MEETING OF THE UPPER THAMES RIVER CONSERVATION AUTHORITY HEARING COMMITTEE
THURSDAY, MARCH 18, 2021 – 1:00pm
Virtual Meeting Due to COVID-19 Pandemic

Re: Permit Application #27/20
Mills Award Drain
Township of Perth South
Our Job No. 218288

Drawing No.: 1 of 2

Subject: Addendum to (January 11, 2021) Hearing Report –
Section 28 Permit Application #27/20 for Proposed
Development in a Floodplain, Development in a River or
Stream Valley, Development Affecting the Conservation
of Land and Alteration to a Watercourse associated with
Mills Creek (aka the Mills Award Drain) - North and
South of Perth Line 29, Township of Perth South.

PLAN, PROFILE, & DETAIL

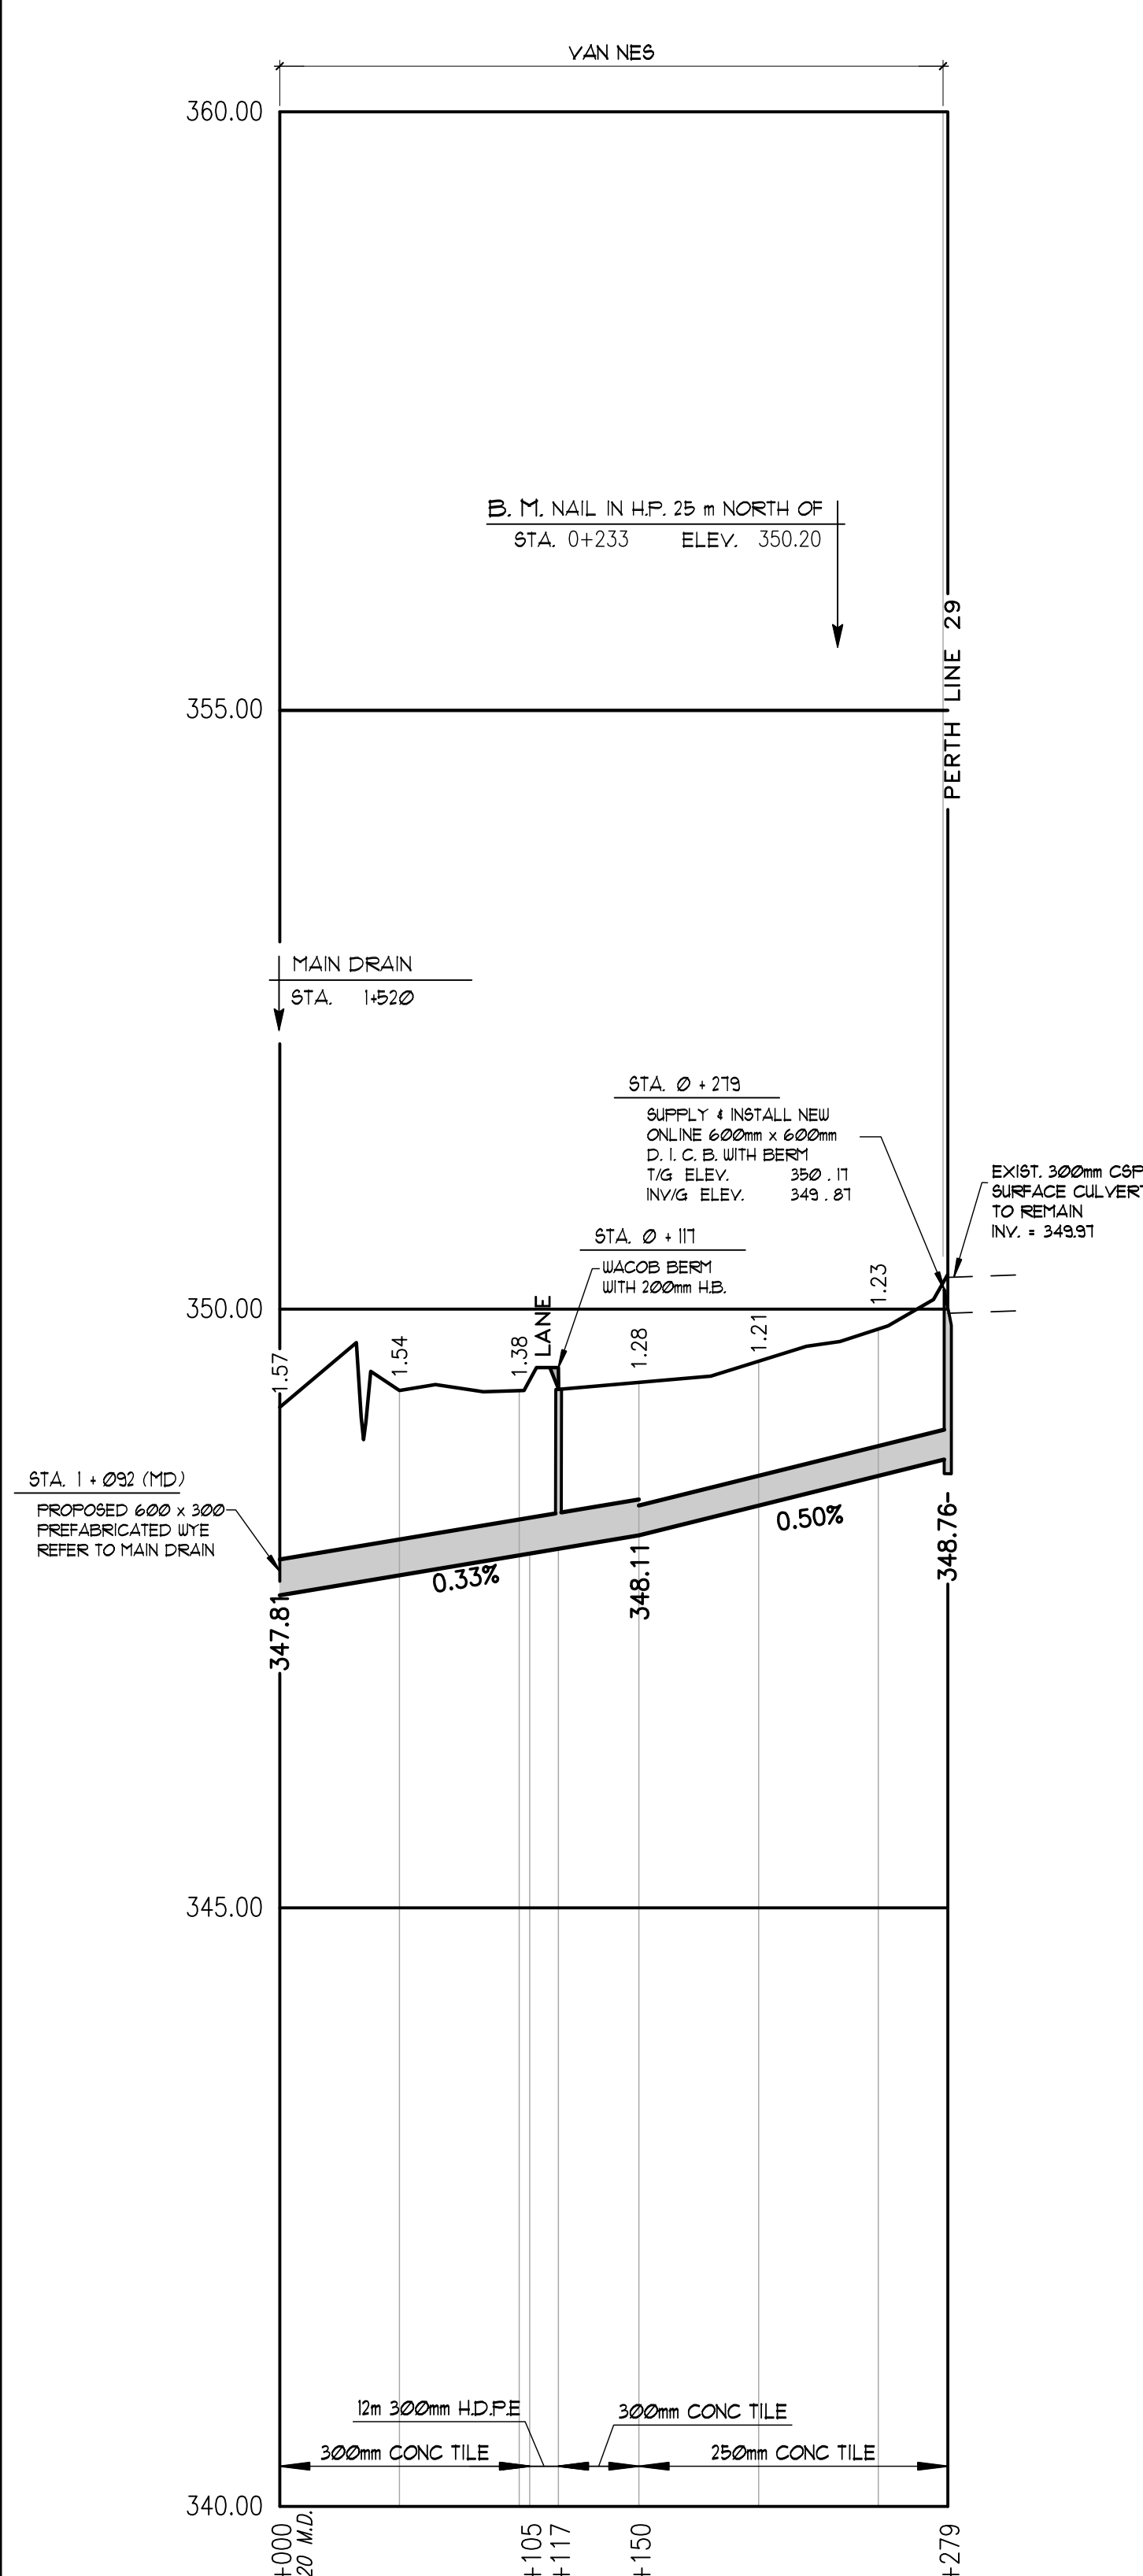
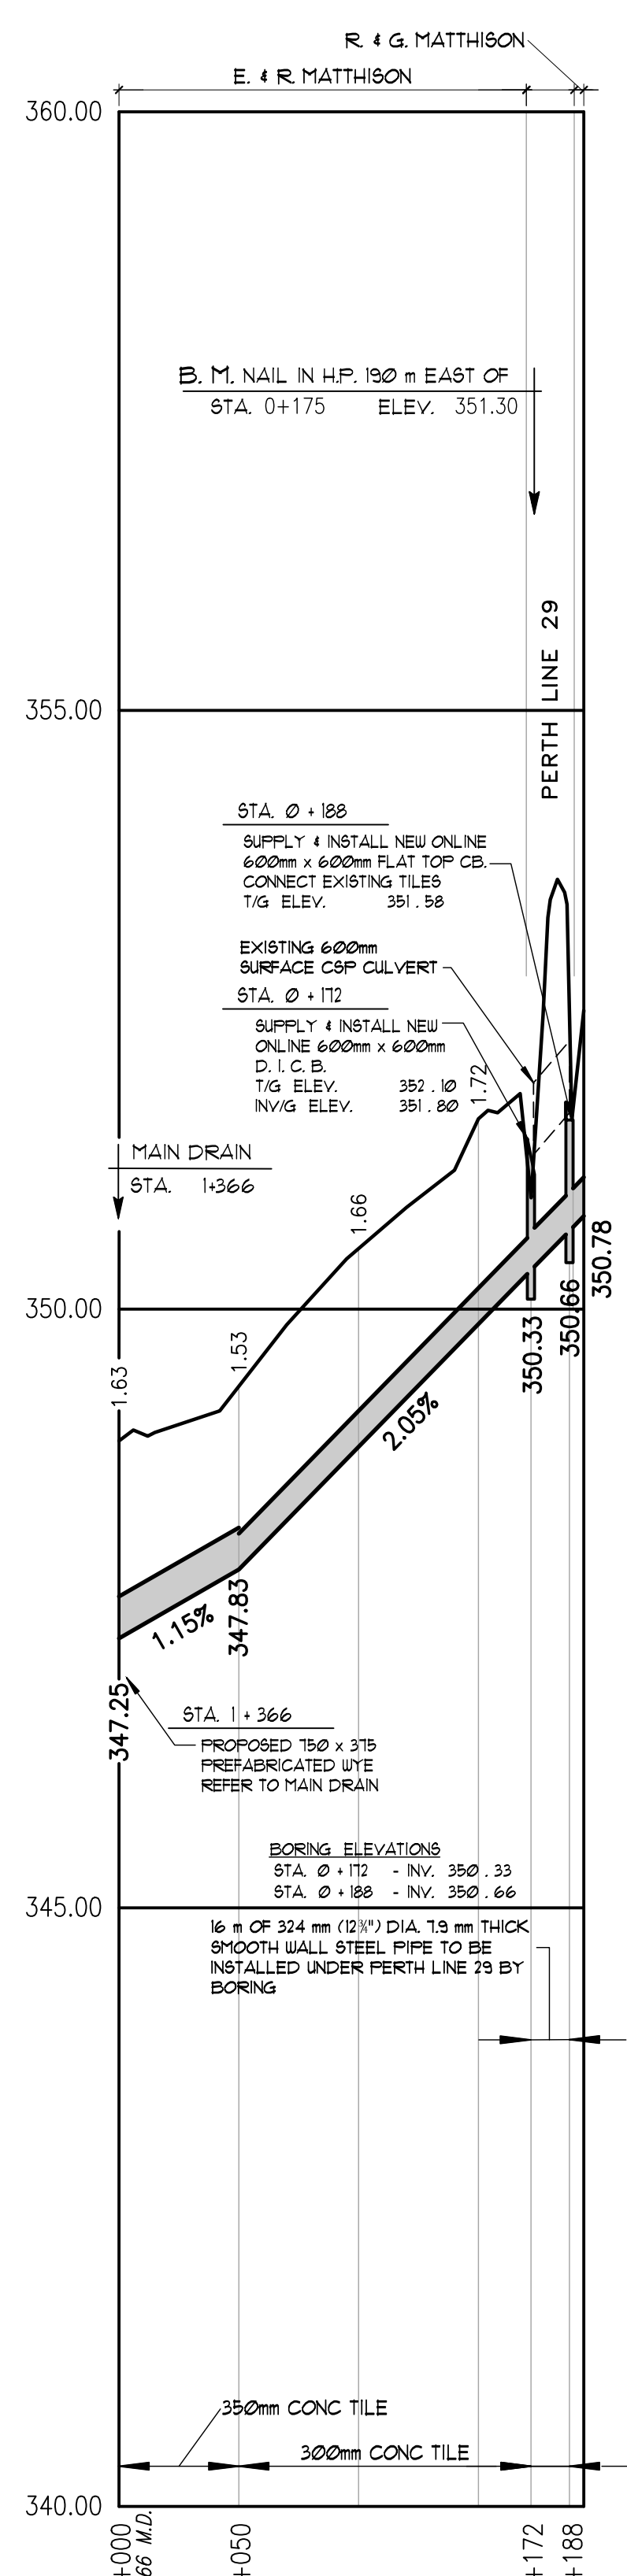
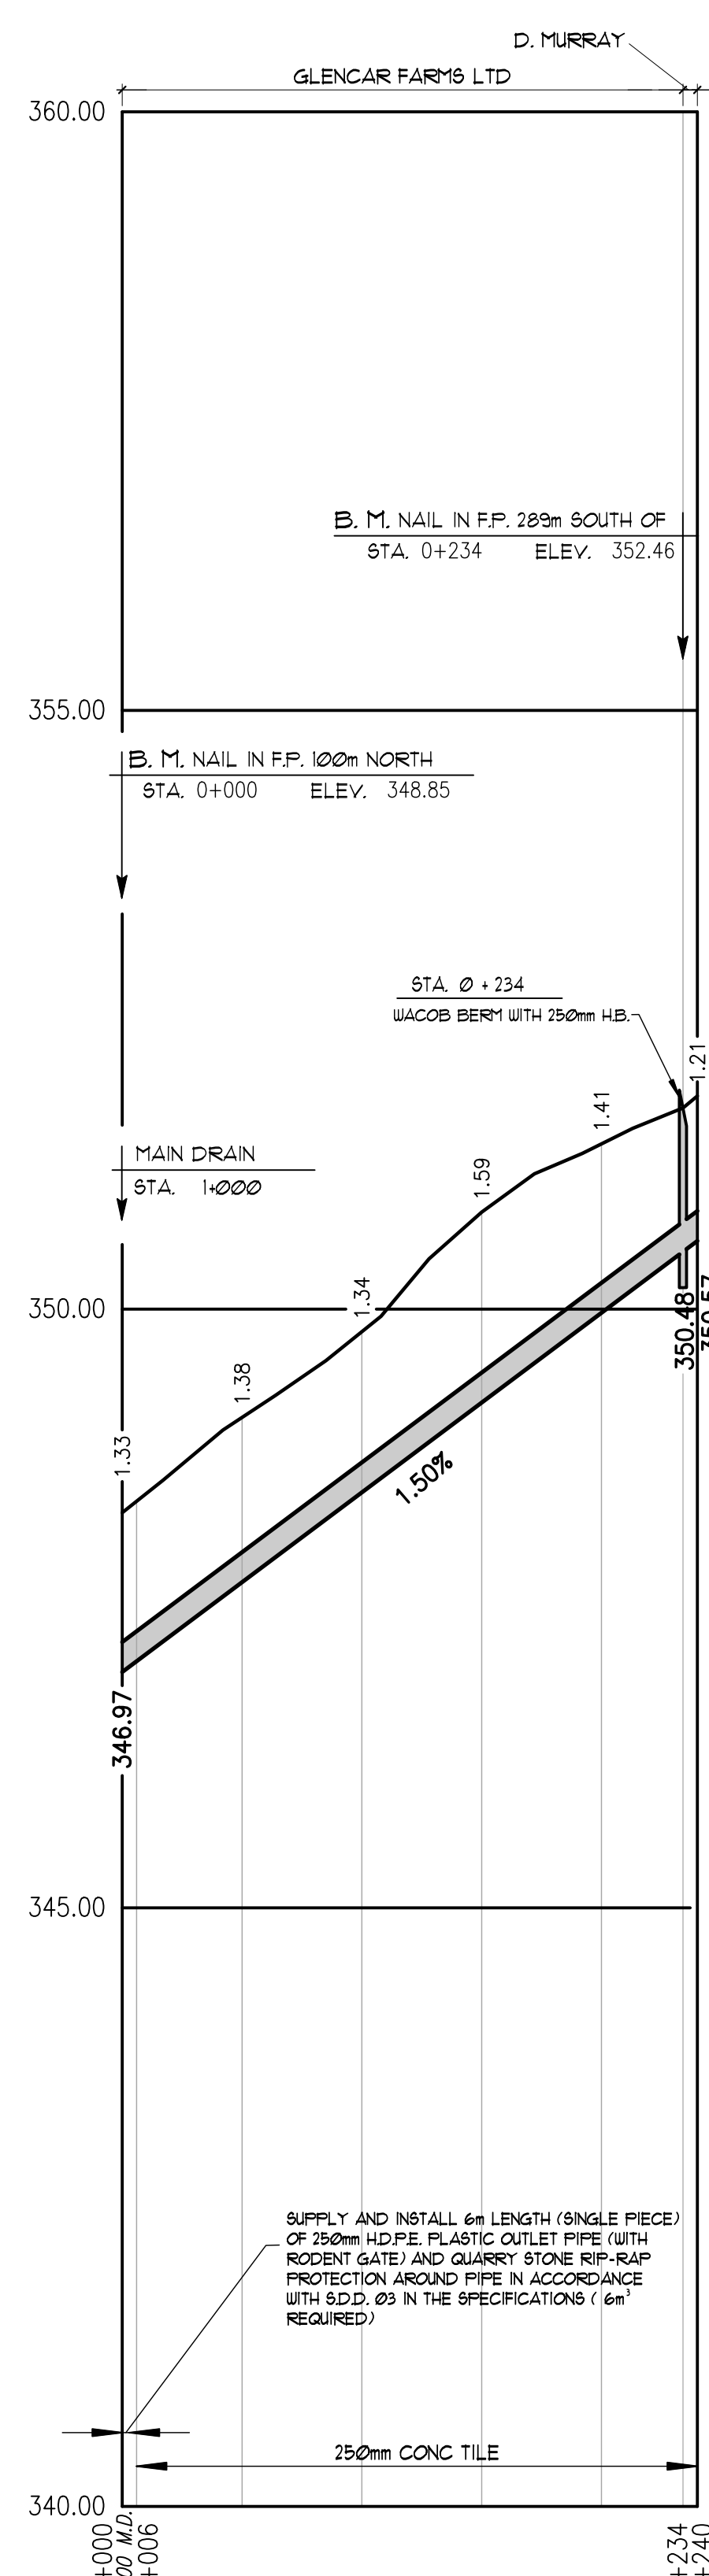
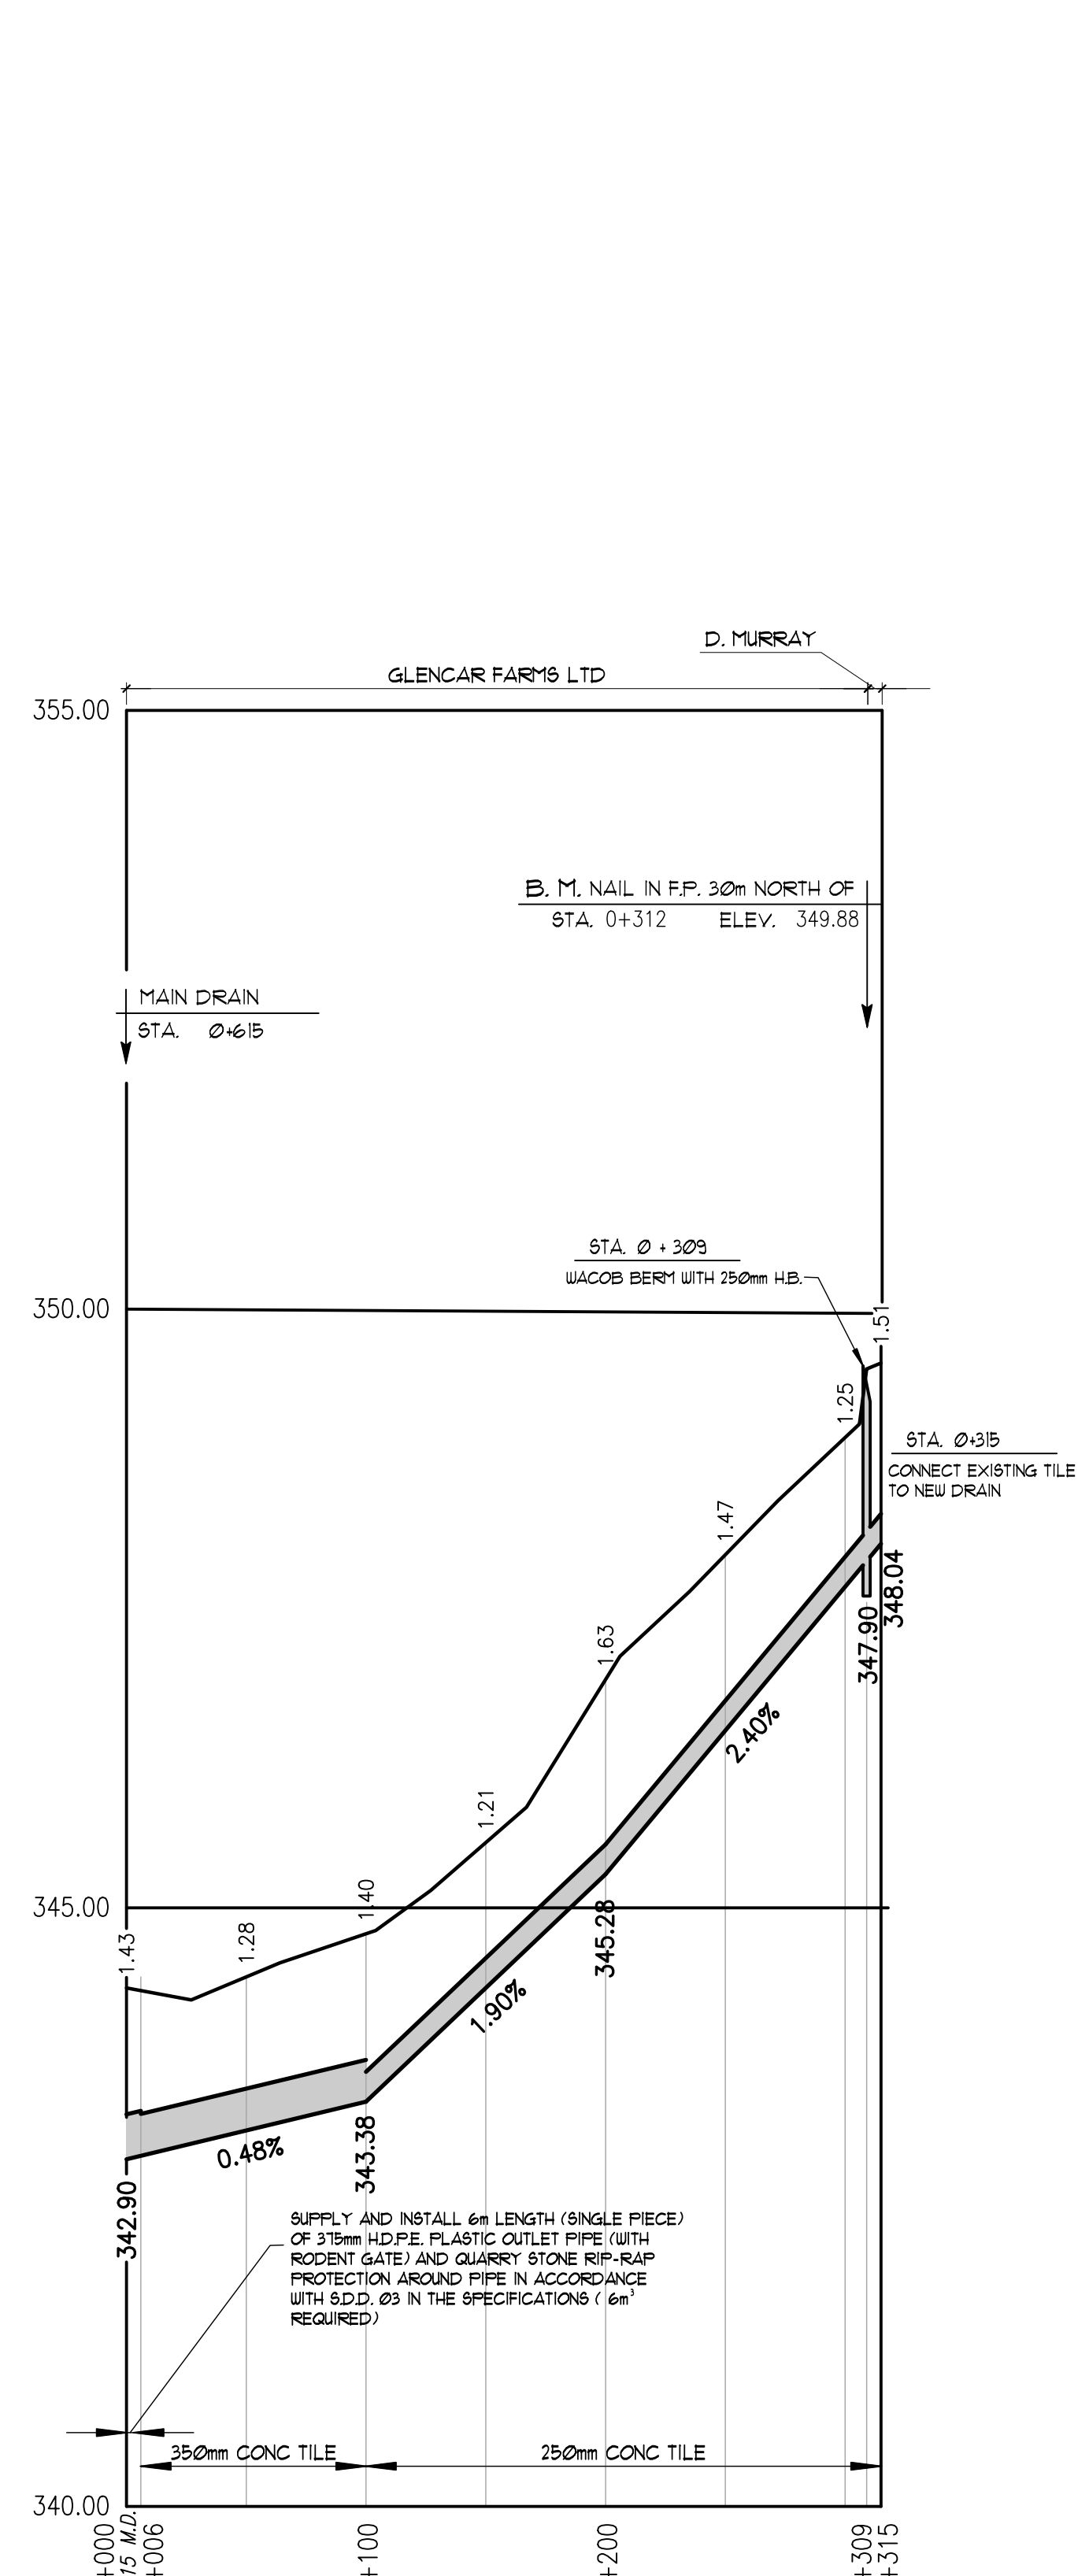
- i. The updated project proposal is not measurably different from the previous proposal. The original proposal was for the enclosure of approximately 2.3 km linear length of watercourse. This enclosure length has been reduced to approximately 1.7 km. Rather than the municipal drain portion stopping at the north end of the Quast property as before, the proposal now also includes converting to municipal drain the entire extent of the watercourse all the way to the confluence of the Avon River to allow for future maintenance dredging. Water and Sediment Control Basins (WASCoBs) are still proposed and their locations have now been more clearly identified on the submitted plans.

- ii. It is unclear if a grassed swale over the entire extent of the enclosure is still proposed as this does not appear on the plans, however, the accompanying letter mentions that *“the above features have been added to the project, in conjunction with others that were previously presented, many of which are considered Best Management Practices, for controlling soil erosion.”* We are presuming that statement to mean the grassed swales are still proposed to be included as per previous swale descriptions and size criteria. (UTRCA staff have asked for confirmation on this from the applicant but have not heard back as of the date of this report.)

- ix. There is no mention in the plans of vegetated buffers to be included adjacent the open watercourse feature. We understand that this proposal is a concept only for review of the enclosure itself and the buffers could be included within the report at the detail design stage. For information purposes we would like to draw your attention to the BMP guidance info from:

- 4) That appropriately sized grass buffers be included along both sides of the remaining open portion of the watercourse in accordance with Agriculture Canada and OMAFRA guidelines as noted above and that these grassed buffer widths be clearly outlined as requirements in the final Drain Report;
